**Summary Updates for Decommissioning Risk Study
and Comments on NEI Review**

Structural Integrity of Spent Fuel Pool Structures Subject to Heavy Loads Drops

NEI Comments: (Section 3.2.4, page 31 to 36)

Figure 4 - Tornado risk regionalization scheme (from NUREG/CR-2944)

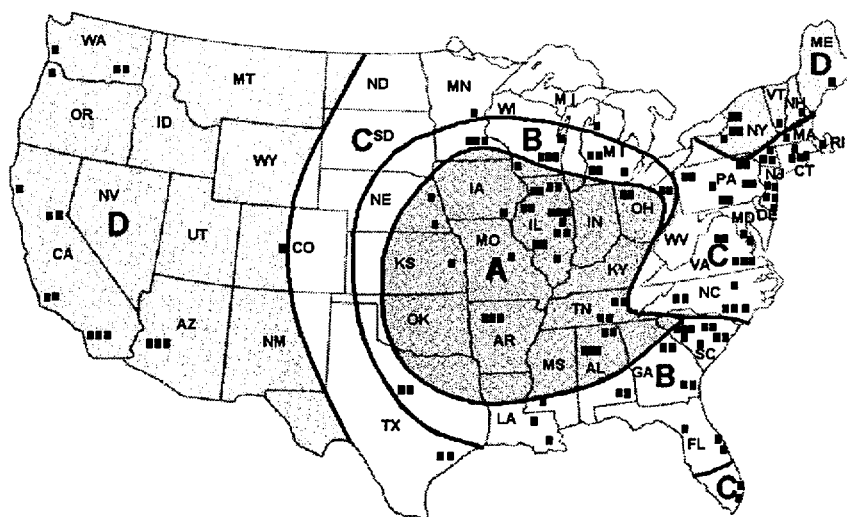
NEI is correct in that the value presented was for the highest tornado region. The exceedance values are best estimate. Because of the rush to release the report, some last minute changes did not get into the draft as released, and **5.6×10^{-7} per year (exceeding an F4) is the correct value.** It is appropriate to use a regionalization even if a region (state) has no sites. For example, if Oklahoma is not considered, the value drops to 5.4×10^{-7} per year.

The tornado induced failure of equipment is based on exceeding an F2 (1.5×10^{-5} per year).

The revised report will include the following table and figure to show the regional variations:
